TCN – 01

Ref: PSER:SCT:NKP-M1627:TCN-01

Sub	Tender Change Notice (TCN-01).	
Job	Design, engineering, manufacturing, supply/delivery, storage, erection, commissioning, trial run, handing over to customer, etc of Fuel oil unloading and storage system for, 3 X 660 MW North Karanpura, Super Thermal Power Project, Jharkhand.	
Ref	01	Tender No. PSER:SCT:NKP-M1627:14.
	02	BHEL's NIT, vide reference no PSER:SCT:NKP-M1627: 4057, dated 15-11-2014.
	03	Other references (if any).

ANNEXURE-I TO TCN-01

DRN.	VN	01/12/14	PACKAGE : FUEL OIL HANDLING SYSTEM
CHKD.	HK	01/12/14	3X660 MW KARANPURA TPS
APPD.	SKB	01/12/14	
DEPT.	NAME	DATE	TITLE
M	SCALE :		FUEL OIL HANDLING SYSTEM LAYOUT
File Name :			BHEL DRG. NO. : PE-DG-405-166-A002
			SHEET NOS. REV. 1 OF 1 1

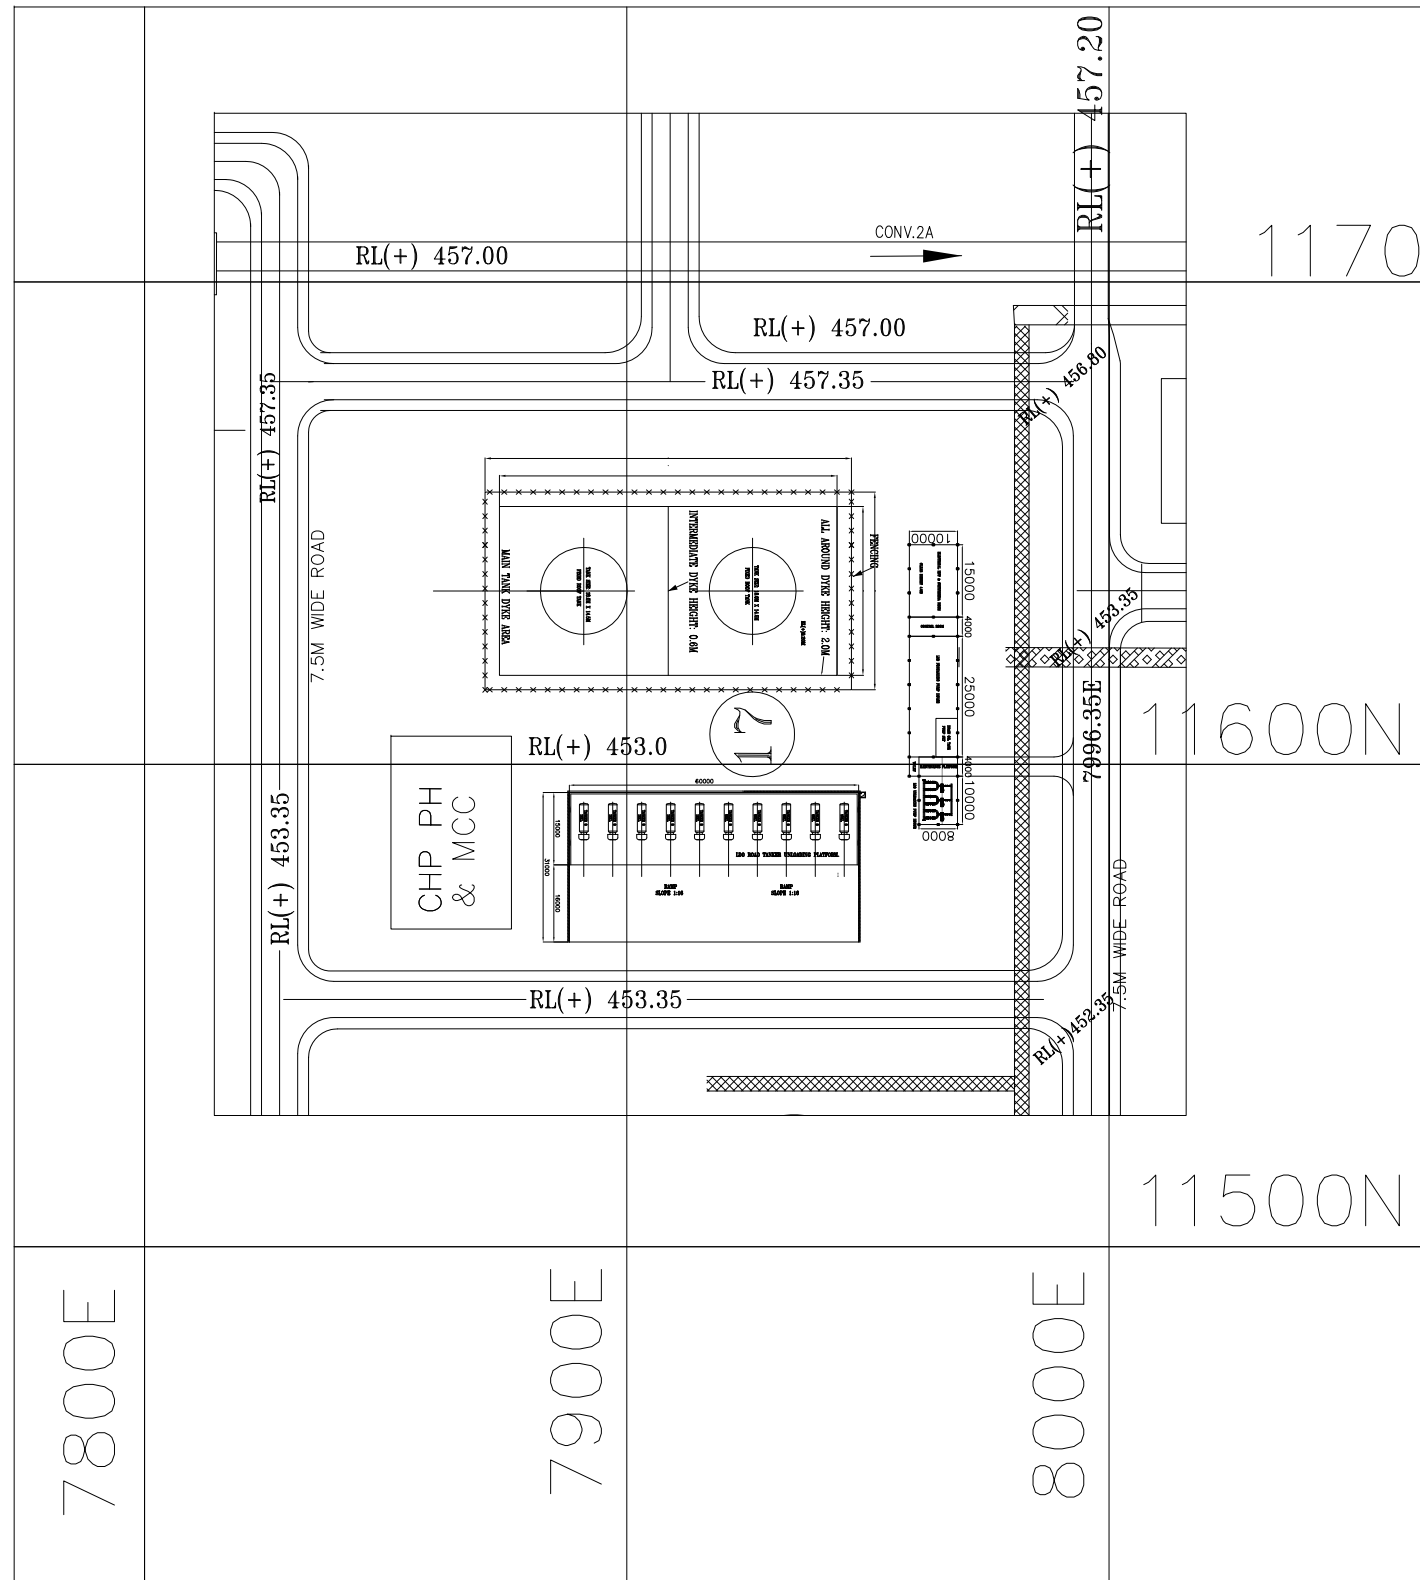
Other points:			
1	GENERAL: FOHS layout changed			Location of FOHS and orientation changed. Revised layout is enclosed for tendering purpose offer preparation.
